3/31/09	Added General Note (F)
DATE	REVISION	
STATE OF HAWAII DEPARTMENT OF TRANSPORTATION HIGHWAYS DIVISION BRIDGE GENERAL NOTES INTERSTATE ROUTE H-1 EXTENSION AND REPAIR OF SCHOOL STREET ON-RAMP RETAINING WALL Project No. H11-01-08 Scale: As Noted Date: Feb., 2009

3/31/09	Revised and/or Added Callouts and Legend
DATE	REVISION
STATE OF HAWAII DEPARTMENT OF TRANSPORTATION HIGHWAYS DIVISION RETAINING WALL REPAIR and EXTENSION EXISTING SITE PLAN INTERSTATE ROUTE H-1 EXTENSION and REPAIR of SCHOOL STREET ON-RAMP RETAINING WALL Project No. H11-01-08	
Scale: As Noted	Date: Feb, 2009
SHEET No. Q3 OF 34 SHEETS

RETAINING WALL REPAIR and EXTENSION

WALLS "K", "L" AND "M" SECTIONS 1
Scale: 3/4"=1'-0"

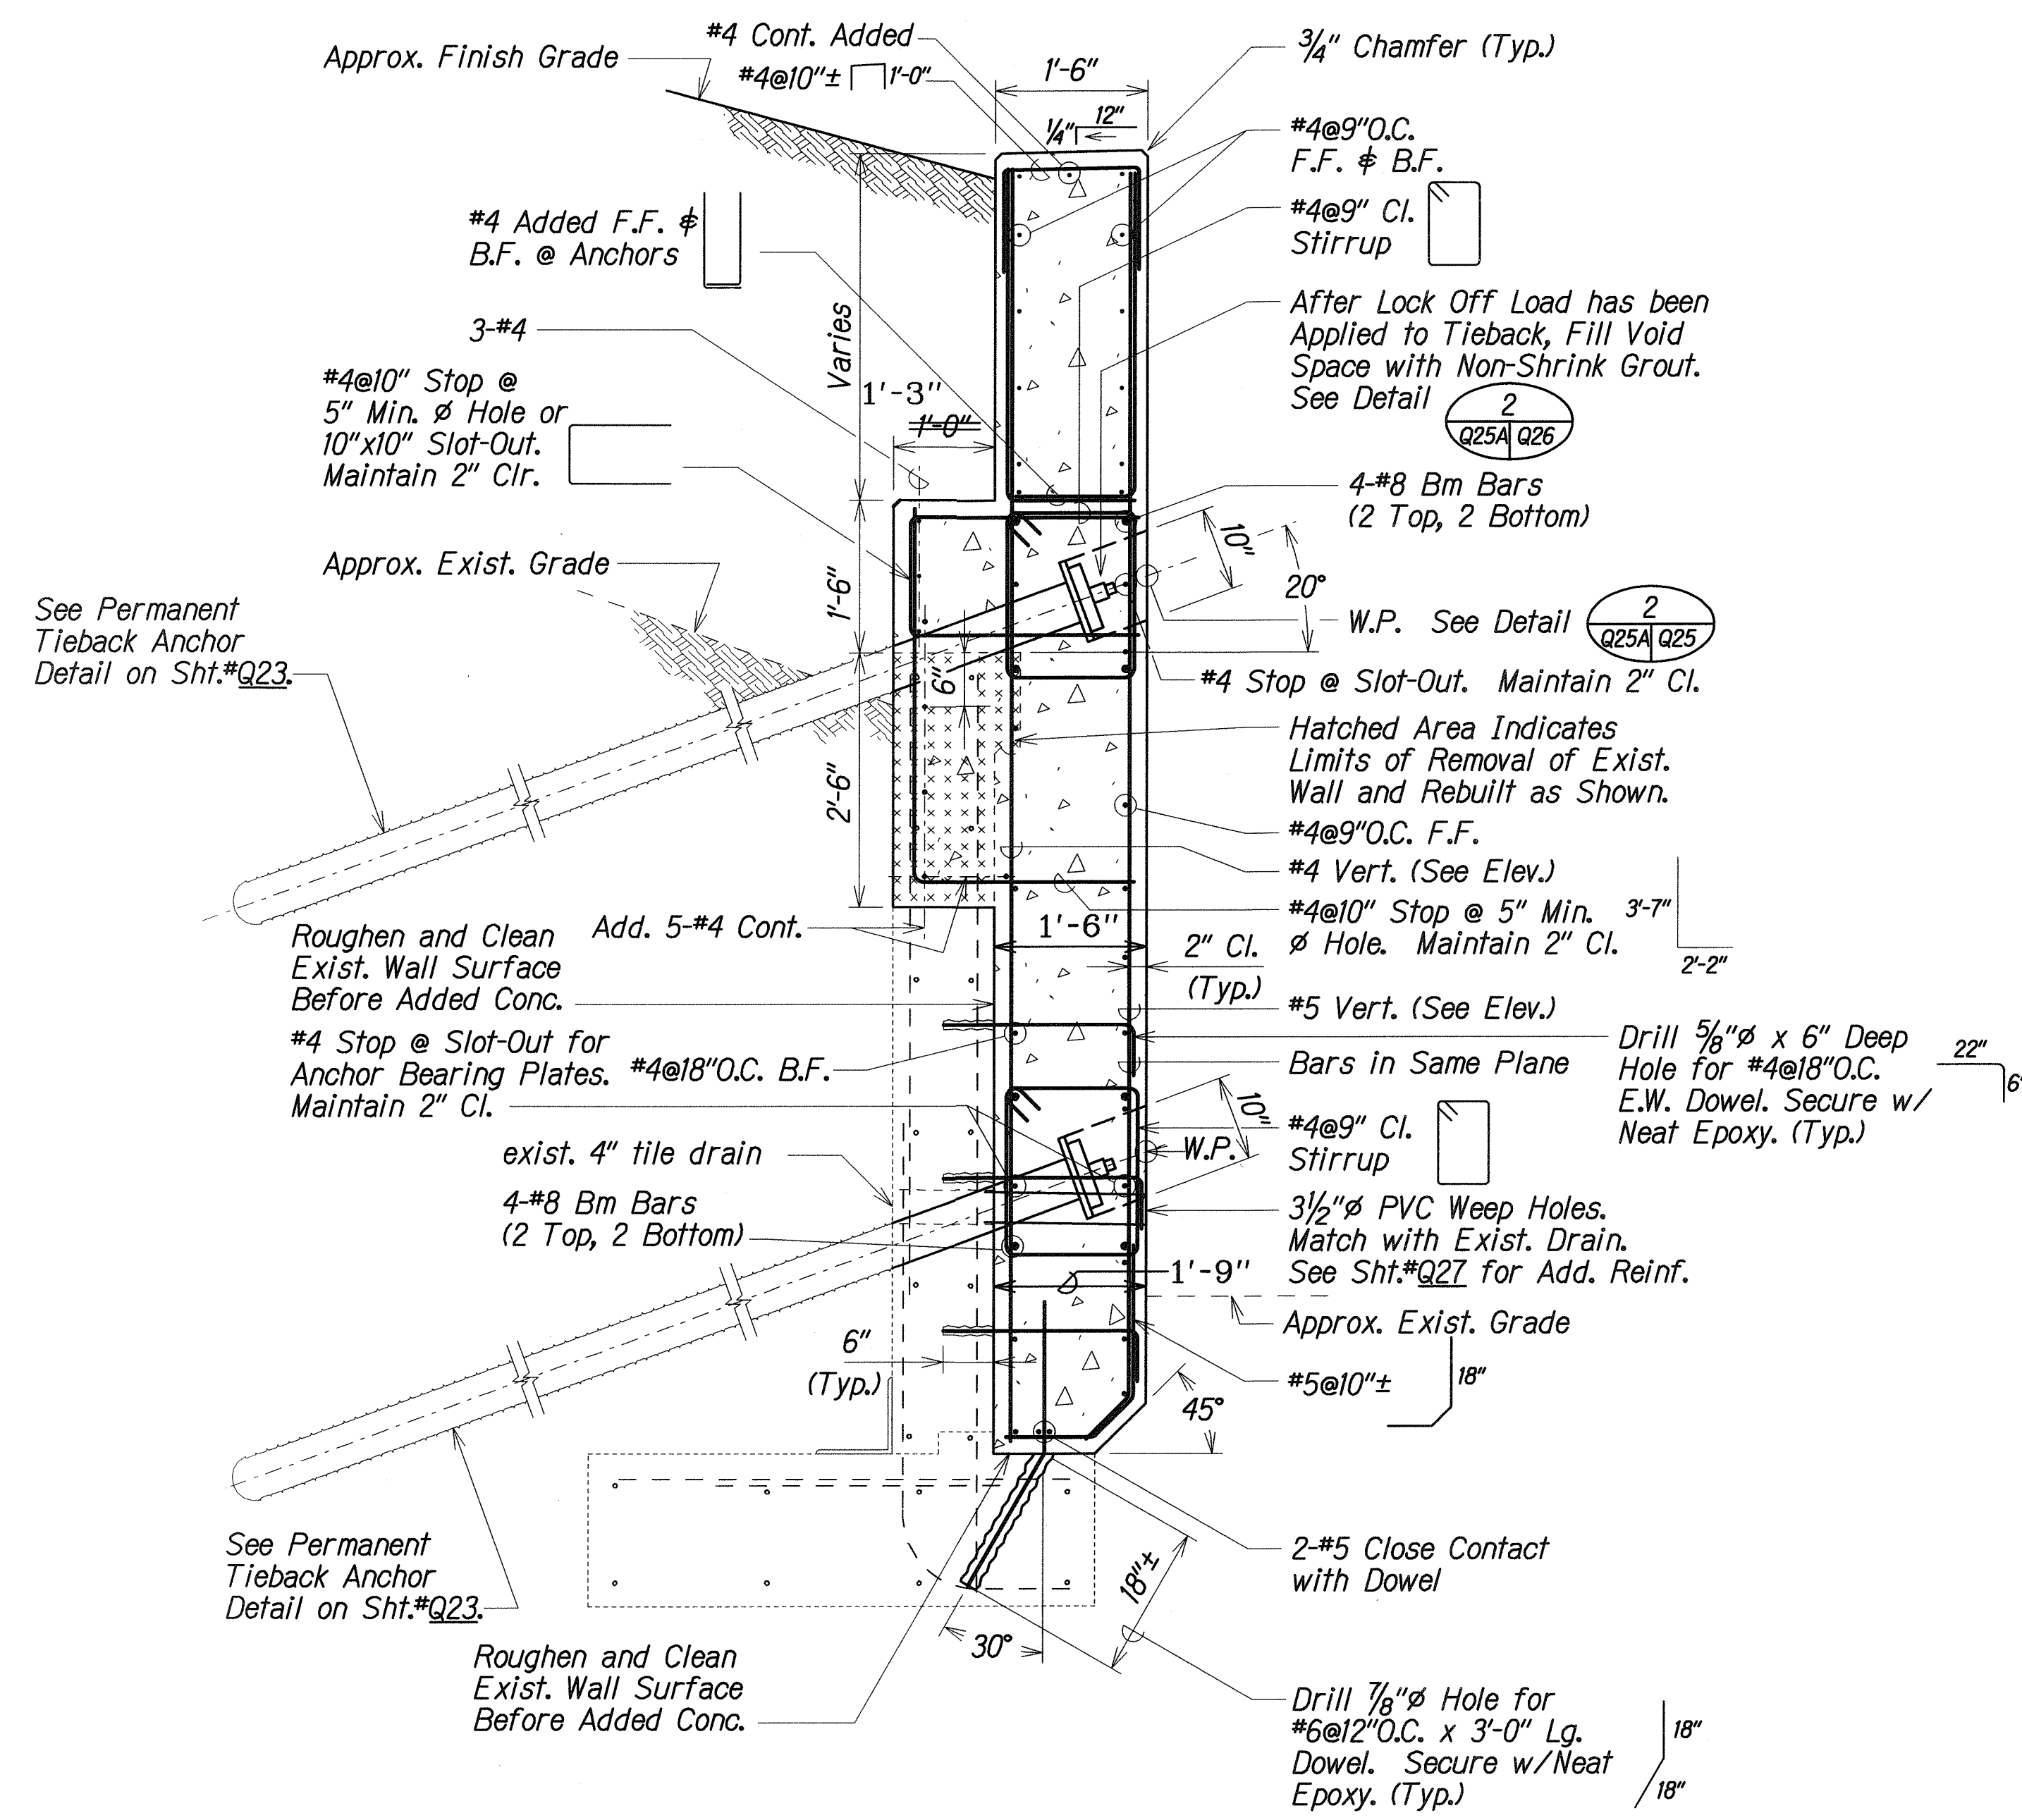
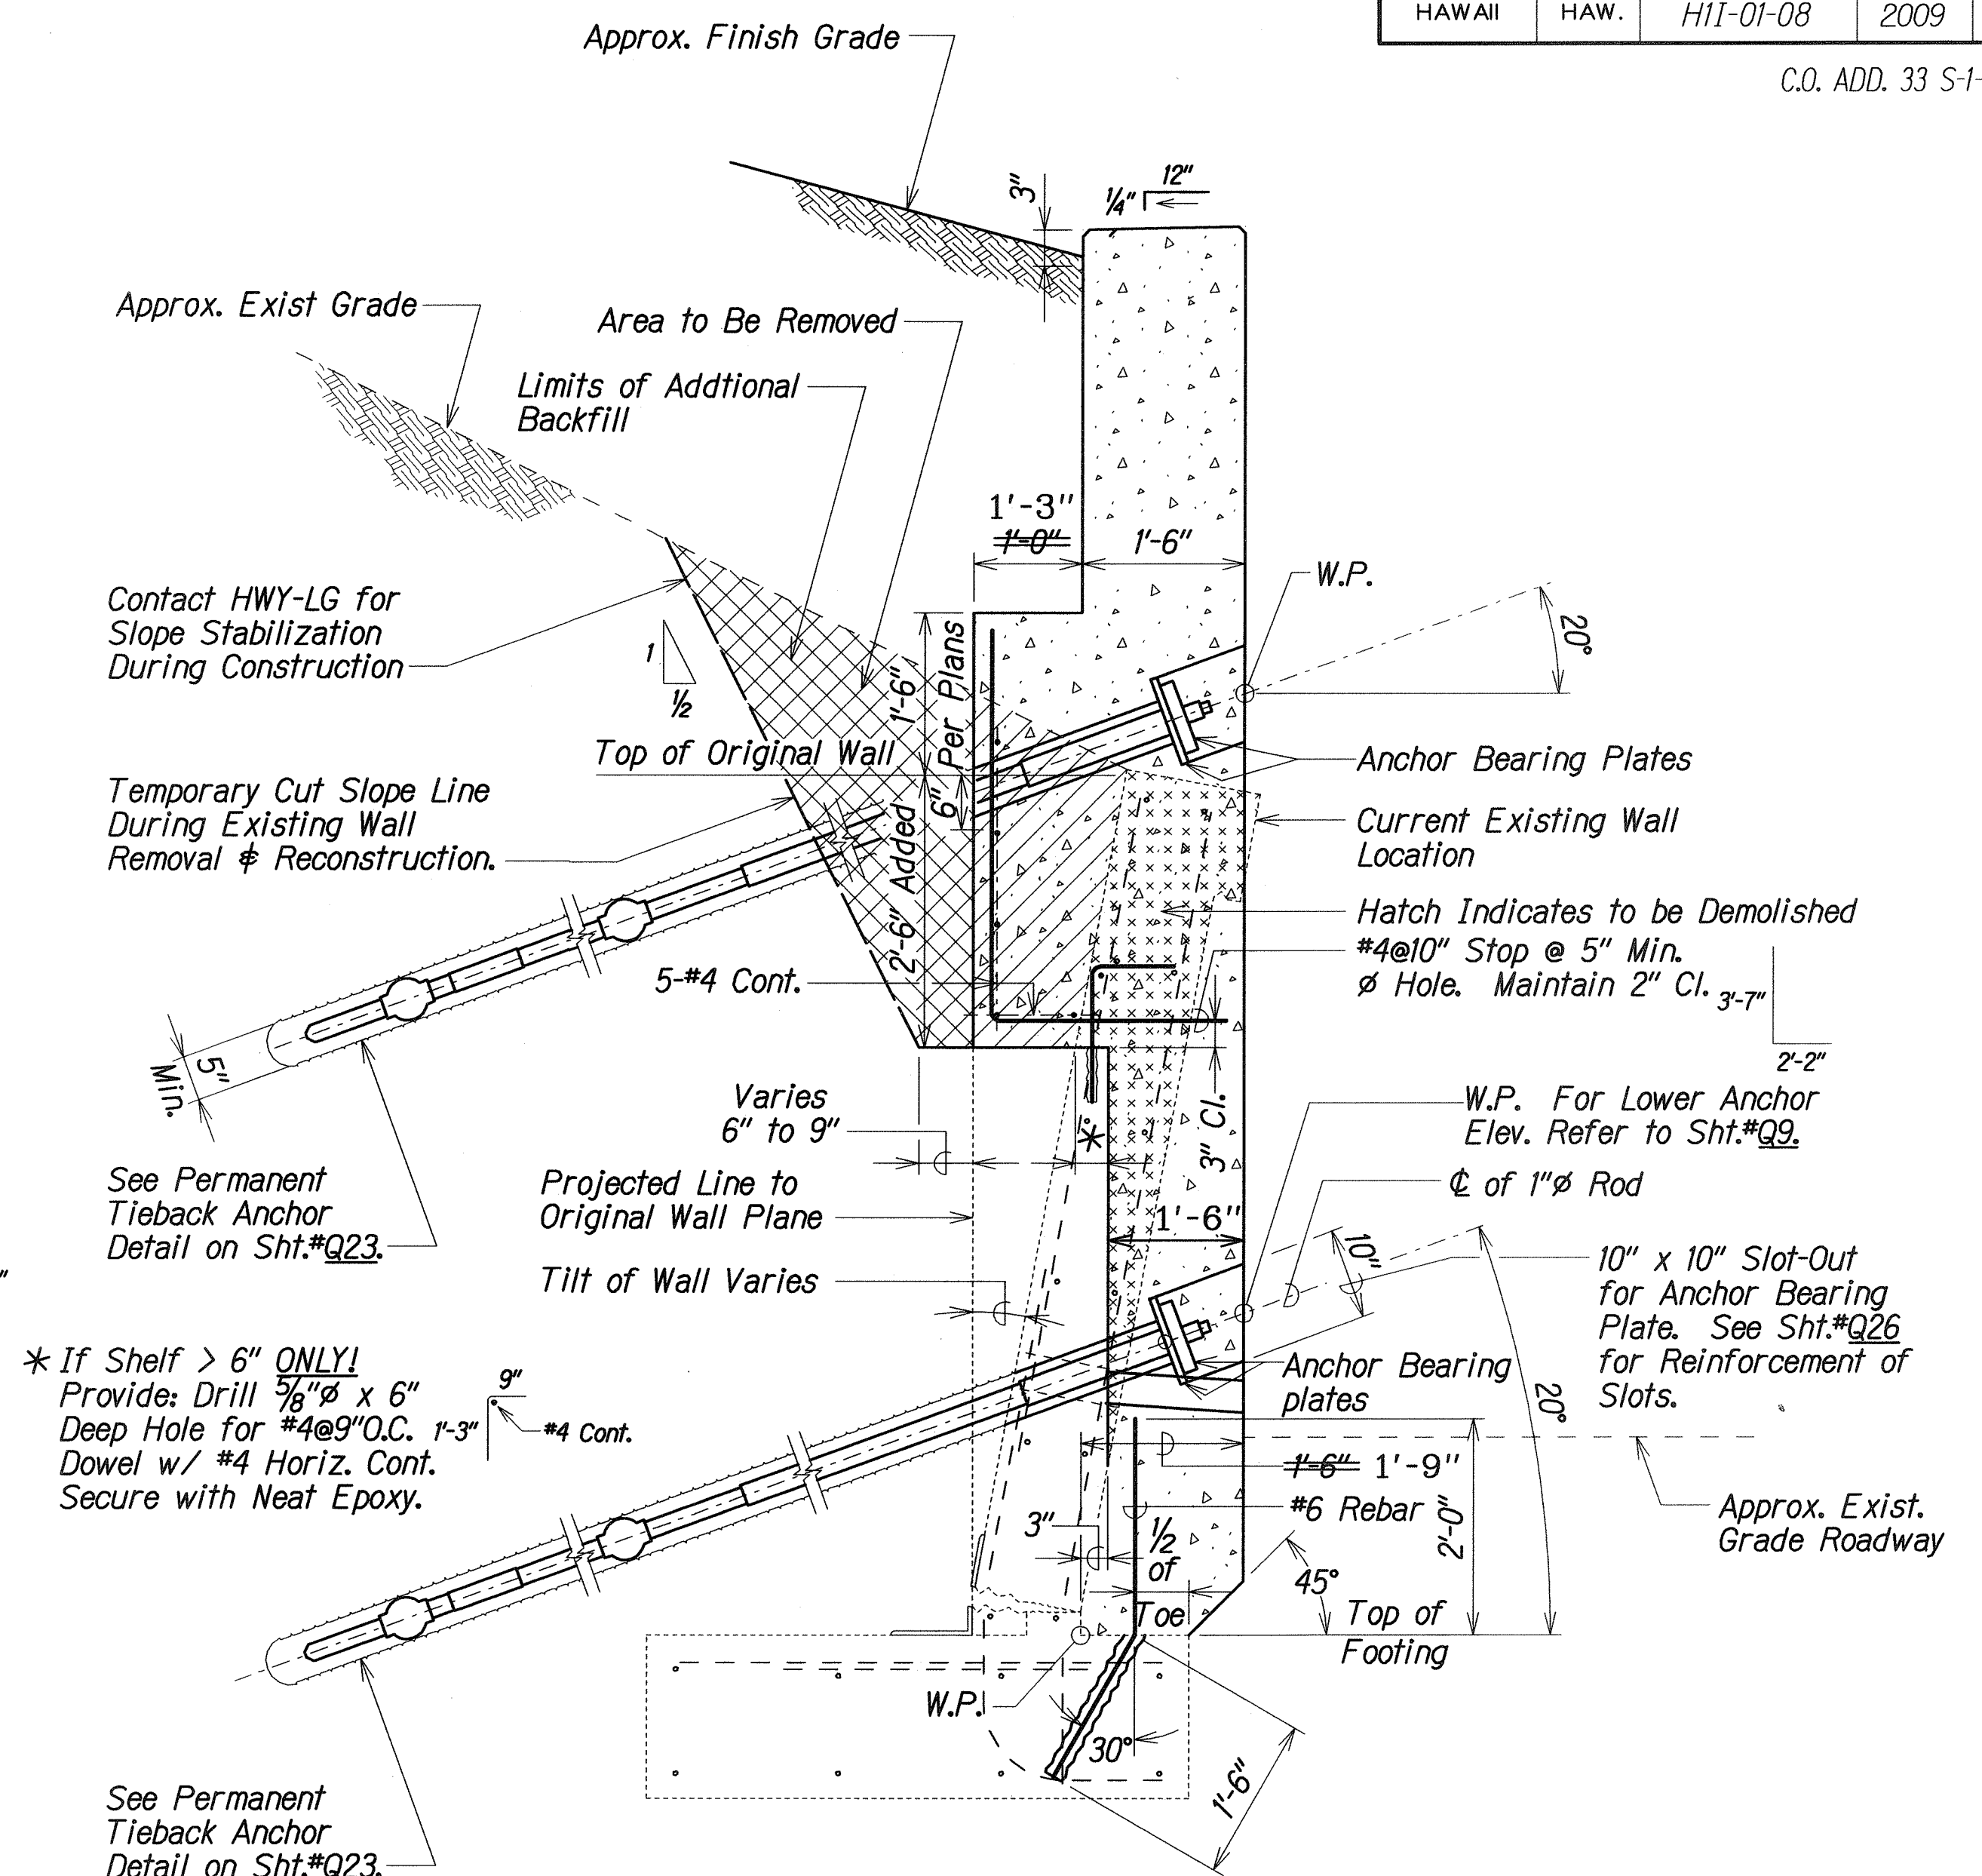
8/17/09	This Sheet was Added as a Change Order
DATE	REVISION
STATE OF HAWAII DEPARTMENT OF TRANSPORTATION HIGHWAYS DIVISION	
RETAINING WALL REPAIR WALLS "K", "L" AND "M" SECTIONS INTERSTATE ROUTE H-1 EXTENSION AND REPAIR OF SCHOOL STREET ON-RAMP RETAINING WALL Project No. H11-01-08	
Scale: As Noted	Date: Feb., 2009
SHEET No. Q25A OF 34 SHEETS
